Access Compliance Report

Public Rights-of-Way

Intersection ID: 2710	Main Street: FAIRVISTA_DR	Cross Street: QUEENSBURY_CT	Location: SE
ADA ID: 85AAD88A8A1E	Ramp Type: PerpDiag	Initial Pass/Fail: Fail	Overall Compliance: No
Severity Score: 8.75			
Codes/Mitigation Info/Possible Solution		Field Measurements/Component Compliance

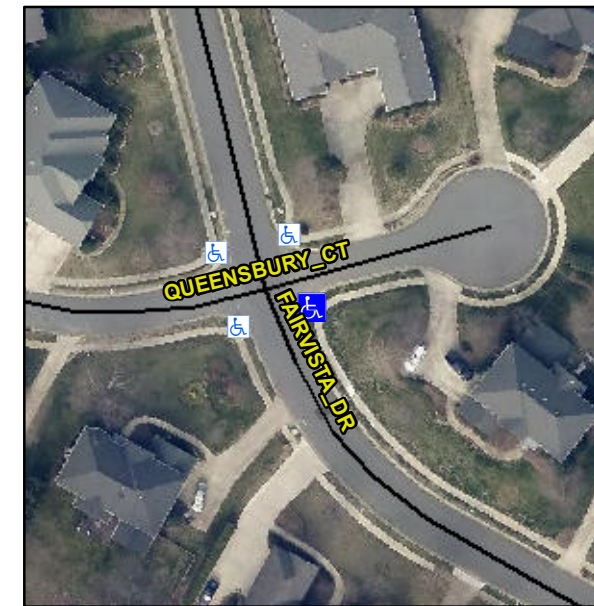
Not Found, R304.5.1

Compliance	Description	Data	Compliance	Description	Data
N/A	Ramp Length (in)	44.0	Yes	Ramp Slope (%)	7.2
No	Ramp Width (in)	45.0	Yes	Ramp XSlope (%)	0.2
N/A	Flare Type LT	N/A	N/A	Flare Type RT	N/A
N/A	Flare Slope LT (%)	N/A	N/A	Flare Slope RT (%)	N/A
N/A	Flare Traversable LT?	N/A	N/A	Flare Traversable RT?	N/A
N/A	Landing Length (in)	N/A	N/A	DWS Provided?	N/A
N/A	Landing Width (in)	N/A	N/A	DWS Contrast?	N/A
N/A	Landing Slope (%)	N/A	N/A	DWS Length (in)	N/A
N/A	Landing X Slope (%)	N/A	N/A	DWS Full Width?	N/A
N/A	Landing Curb? (Y/N)	N/A	N/A	DWS Offset (in)	N/A
N/A	Shared Landing?	N/A			
N/A	Gutter Ponding?	N/A	N/A	Gutter Slope (%)	N/A
N/A	Gutter Lip Ht (in)	N/A	N/A	Gutter X Slope (%)	N/A
N/A	Painted X Walk1?	No	N/A	Painted X Walk2?	No
	X Walk 1 Direction	To N		X Walk 2 Direction	To W
N/A	X Walk 1 Width (in)	N/A	N/A	X Walk 2 Width (in)	N/A
	X Walk 1 Slope (%)	3.0		X Walk 2 Slope (%)	2.1
	X Walk 1 X Slope (%)	0.8		X Walk 2 X Slope (%)	0.2

Remove & Replace Curb Ramp With Two New Directional Ramps or Equivalent.
